APPLICATION NO.	FILING DATE	FIRST NAMED INVENTOR	ATTORNEY DOCKET NO.	CONFIRMATION NO.
10/820,080	04/06/2004	Paul Ciccone	SYNT-0237	7100
53443	7590	12/28/2007	EXAMINER	
WOODCOCK WASHBURN LLP			RAMANA, ANURADHA	
CIRA CENTRE, 12TH FLOOR			ART UNIT	PAPER NUMBER
2929 ARCH STREET			3733	
PHILADELPHIA, PA 19104-2891			MAIL DATE	DELIVERY MODE
			12/28/2007	PAPER

Office Action Summary	Application No.	Applicant(s)
	10/820,080	CICCONE ET AL. CT
	Examiner	Art Unit
	Anu Ramana	3733

DETAILED ACTION

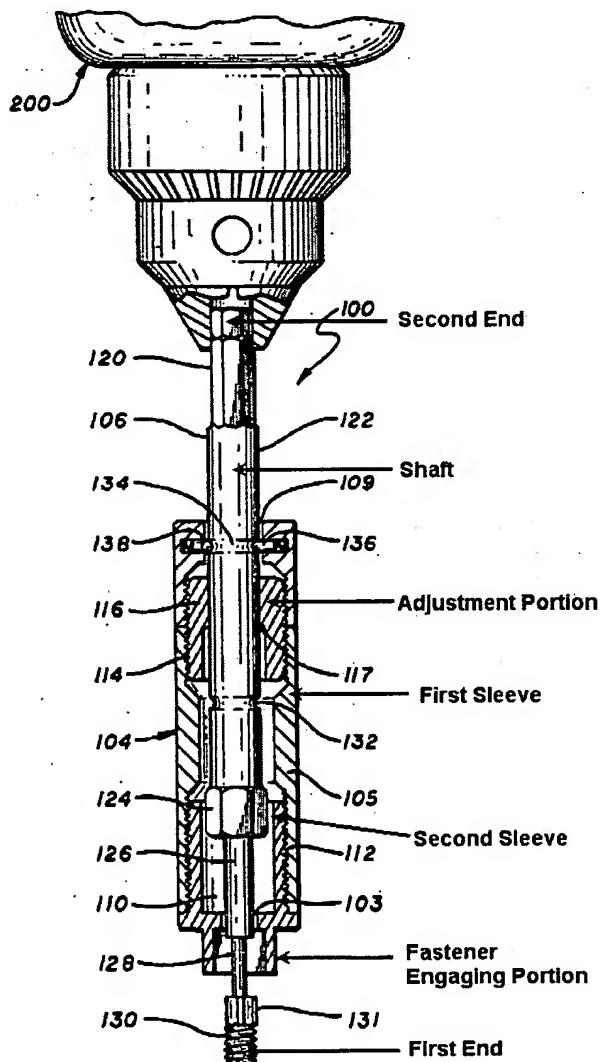
Lemke et al. disclose an adjustable tool including: a shaft (122, 116) with calibration markings (132, 134); a cutting portion 130, i.e. a portion capable of cutting

into material; a fastener engaging portion 102; an adjustment portion 116; and an adjustment mechanism including a first sleeve 105 and a second sleeve 112 mounted on the shaft wherein the cutting portion and the fastener engaging portion can be rotated at different speeds with respect to one another (Figs. 4 and 5, col. 6, lines 47-68, col. 7 and col. 8, lines 1-2). See marked up Fig. 5 from Lemke et al. below.

Claims 1 and 38 recite a "shaft comprising an adjustment portion that is externally threaded." It is the Examiner's position that Applicants' claimed invention is anticipated by Lemke et al. since the claim does not require the adjustment portion to be monolithically formed with the shaft. Lemke et al. clearly show a shaft 122 having an adjustment portion 116.
